Case No. 20-1951-PET

Re: GMP Request for non-substantial change or amendment to CPG 7628

Vermonters for a Clean Environment (VCE) appreciates the opportunity to comment<sup>1</sup> on Green Mountain Power's request for non-substantial change or amendment to CPG 7628 for the GMP Lowell Wind project.

Photos, below, of same area as video, above, with GPS location identifying LS-A22.

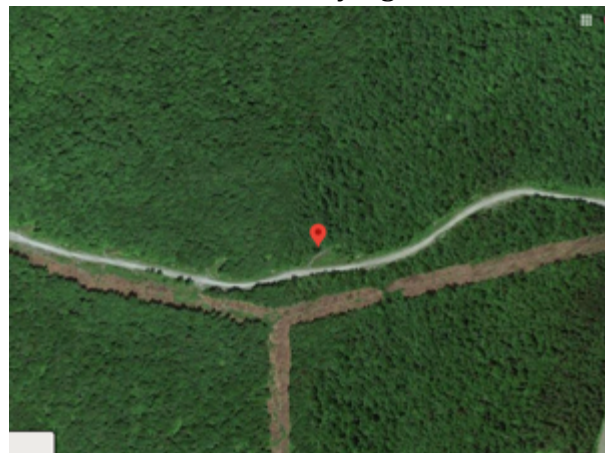
During a subsequent visit to the site by a member of VCE, it was seen that GMP tried to stop the erosion under LS-A22, a level spreader in this immediate area, with a crude attempted remedy of laying logs perpendicular to the erosion channels being formed, and anchoring these logs down with crude pegs made from sticks. We do not know if ANR issued the required authorization under the Vermont Construction Stormwater Permit (#3-9020) for disturbance associated with construction activities.

Our investigation showed clearly that, instead of remedying the erosion situation, the water velocity increased under, around, and especially over the logs, scouring the ground directly under the downhill side of the logs by the water cascading over the logs during very heavy rains. Water velocity is the most destructive state of water, and the presence of these logs actually increases the velocity of the water, similar to curvature along the top of an airplane wing increasing air velocity there.

We found that level spread LS-A22 spreader is concentrating flow, eroding soil resulting in new stream channels in the headwater areas of the mountain, as stormwater runoff did not disperse as predicted, but is instead channelizing. See the two short videos, below, from 2017 and 2019.<sup>11</sup>

Failure of level spreaders on steep slopes was identified as a potential issue prior to issuance of the stormwater permits and 401 Water Quality Certificate. GMP's proposed change to LS-A24, making it even steeper, raises the potential for failure as VCE has documented is occurring with LS-A22.
